## Staff Report for the Hearing Examiner

**Permit Number:** 16 02933

**Project Name:** Shadowhawk Preliminary Plat

**Type of Application:** Preliminary Subdivision

Revised Site Plan

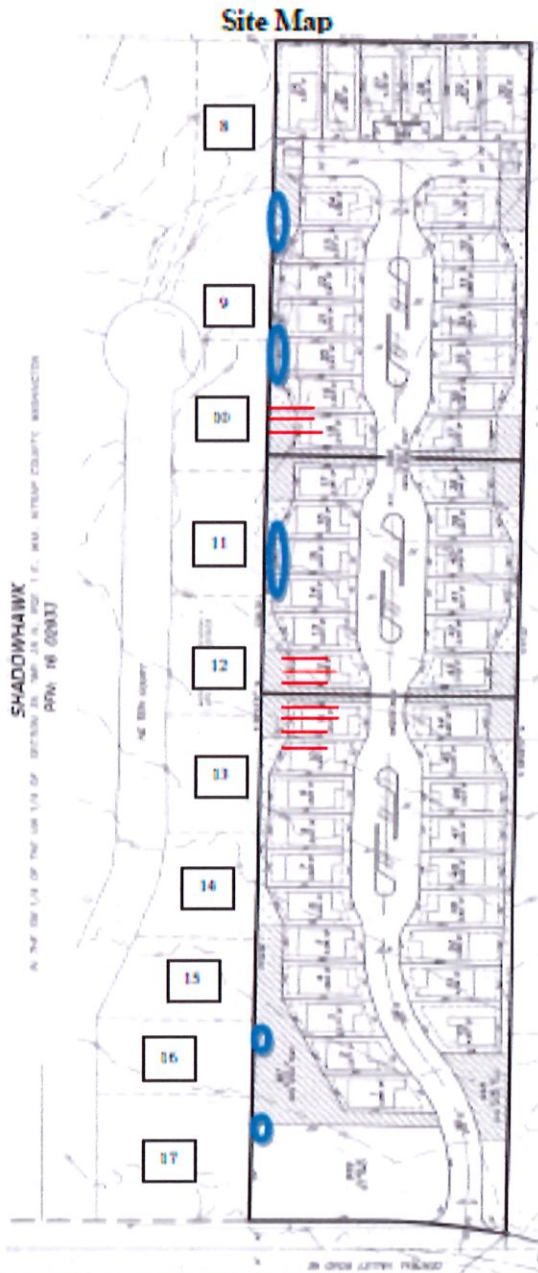
*Staff Comment: The revised site plan dated April 12, 2017 shows sidewalks on both sides of the private roadway internal to the plat. To increase safety, reduce pedestrian and vehicle conflicts, staff recommends sidewalks on both sides of the roadway due to project traffic volumes based on 52 dwelling units (over 400 ADT). The site plan shows five-foot wide sidewalks on both sides of the private road in the plat. Frontage improvements are required along Central Valley road for pedestrian access.*

*Staff Comment: Landscaping is required along Central Valley Road and the storm drainage facility. The applicant is proposing street trees along the private roadway and around the recreation facility. Notes on the revised site plan state that all significant trees will be removed from the site. The applicant has supported some landscaping and fencing along the north property line to act only as a separation buffer. Based on the outcome of the arborist report to address wind throw, the north property line may require less landscaping. The final landscape plan will need to be consistent with the requirements in this section and KCC Chapter 17.385.*

*Staff Comments: As required the recreation facility will be located near the front vs. centrally located within the plat. Provisions must be made to centrally locate and provide a level area to provide a safe location (Tract 996). The proposal includes play equipment to be installed near Central Valley Road.*

4. The recreational facility shall be moved from the current location adjacent to Central Valley Road to a more central location within the subdivision, consistent with KCC 16.24.040.H
